Re: Initial Submission Review – Highpointe Lift Station Capacity Improvements Project – CSP
Application Number: **DA-1746-16**
Case Number: **2016-6043-00**

Initial Submission Review

TRADITIONAL SOLID MASONRY WALL

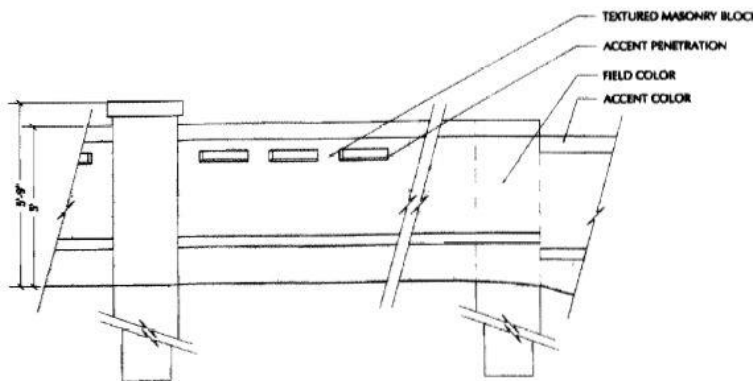
3A. Please revise the proposed masonry fence to match the fence identified in the High Point at DIA Framework Development Plan / what is existing along Dunkirk Street north of 64th Avenue. Below are two images that show what fence is identified in the approved Framework Development Plan and approved Contextual Site Plan, respectively.
